#315 Baltimore Avenue, Takoma Park

PRELIMINARY CONSULTATION 5/22/13

Preliminary Consultation
MONTGOMERY COUNTY HISTORIC PRESERVATION COMMISSION
STAFF REPORT

Address:	7315 Baltimore Avenue, Takoma Park	Meeting Date:	5/22/2013
Resource:	Contributing Resource Takoma Park Historic District	Report Date:	5/15/2013
Applicant:	Brian Finlay	Public Notice:	5/8/2013
Review:	Preliminary Consultation	Tax Credit:	N/A
Case Number:	N/A	Staff:	Josh Silver
PROPOSAL:	Construction of addition and other alterations

ROOF PLAN
1" = 20' 4/1/13

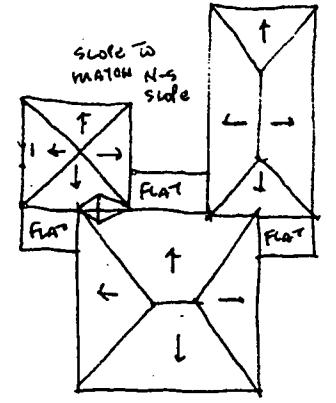
REMOVE WINDOWS (RELOCATE DOORS?)
ADD SKYLIGHT?

NORTH ELEVATION

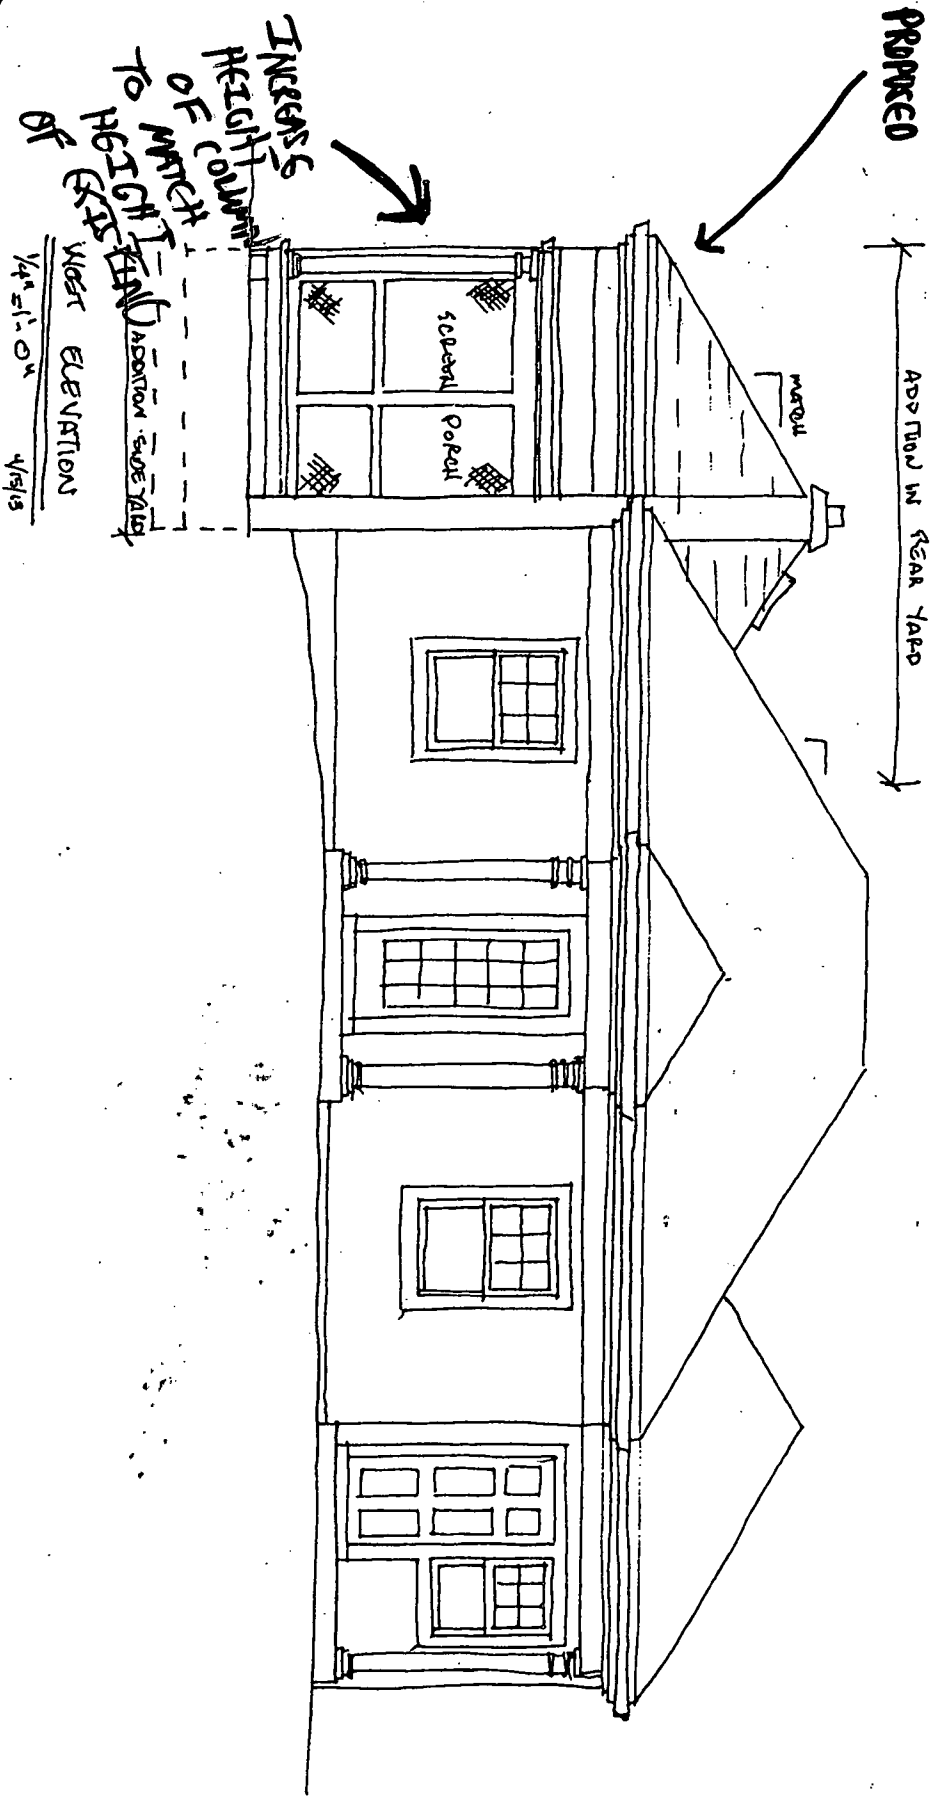
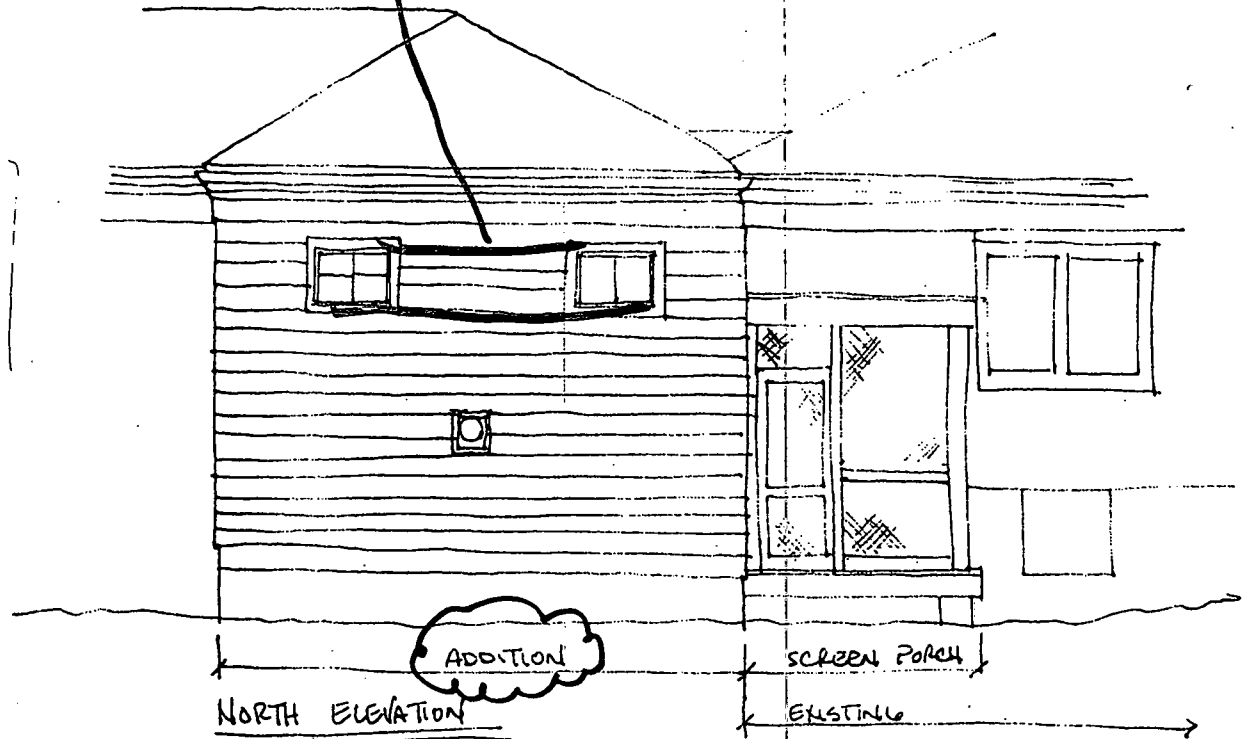
HORIZONTAL WINDOW BAND SUGGESTION
(MAX)

PROPORTIONS (N) ELE. WINDOWS OR SHARP

EAST ELEVATION
1/4" = 1'-0" 4/15/13

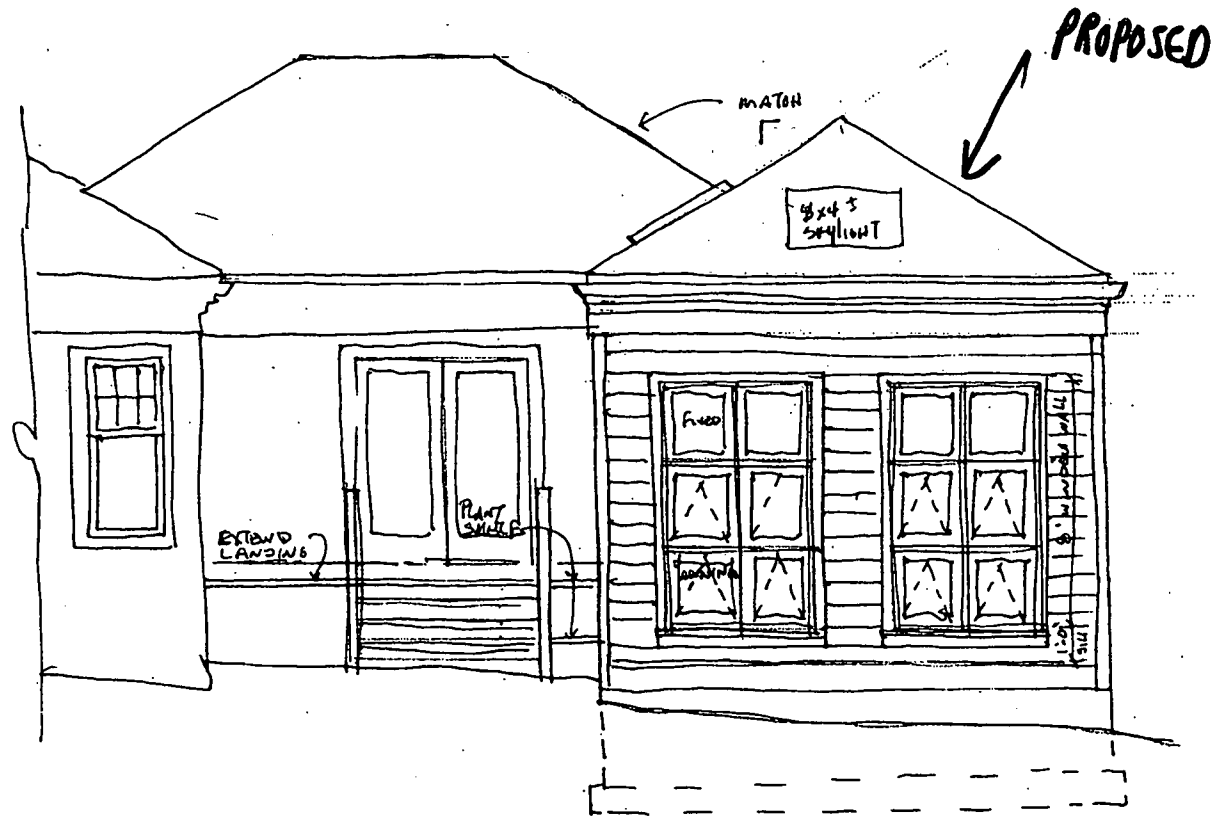
RELOCATE SCREEN PORCH BETWEEN ADDITIONS
ADD SHARPS

MAT./DETAILS OF FRONT PORCH -- COLUMNS (LESS FORMAL)
SYMMETRY ADD COLUMNS OF OTHER FRONT PORCH
 (R) SIDE
